**MULTI-CONTOUR SEAT - ADJUSTMENT OR MASSAGE FEATURE
INOPERATIVE - SCMG AND/OR SCMH AIR PUMP CONTINUALLY RUNS -
BUILT ON OR BEFORE 4/21/2015**

TSB 15-0093

2015 F-150

Figure 1 - Article 15-0093

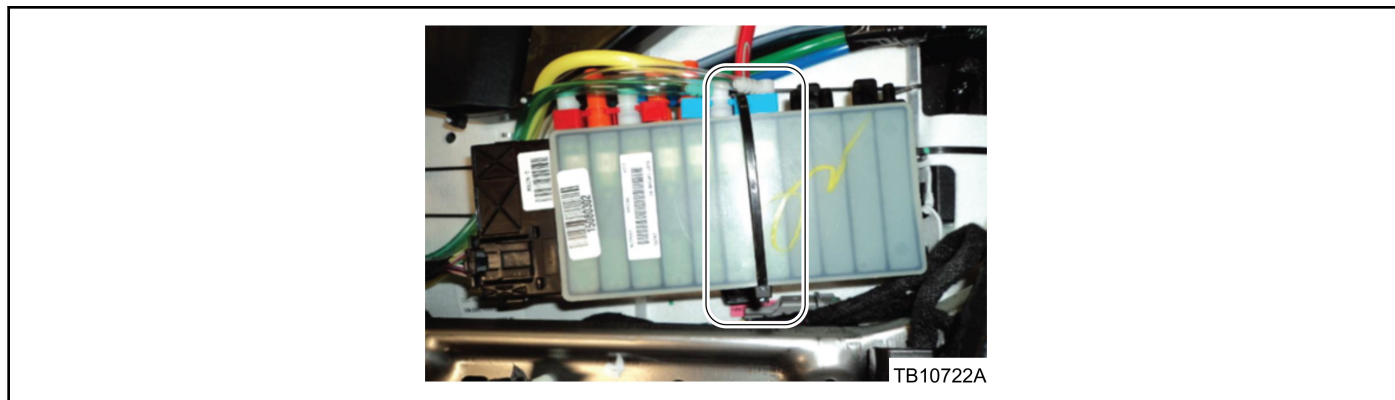
1. Does the vehicle exhibit one or more front seats with an inoperative seat adjustment, massage feature and/or an SCMG or SCMH air pump continually running?
 - a. Yes - proceed to Step 2.
 - b. No - this article does not apply.
2. Access both the SCMG and the SCMH. Refer to the Workshop Manual (WSM), Section 501-10.
 - a. Removal of the modules is not necessary.
3. Use a nylon cable tie at least 254 mm (10 in.) long and wrap one around each the SCMG and the SCMH and each blue connector to secure the connection. (Figure 1)
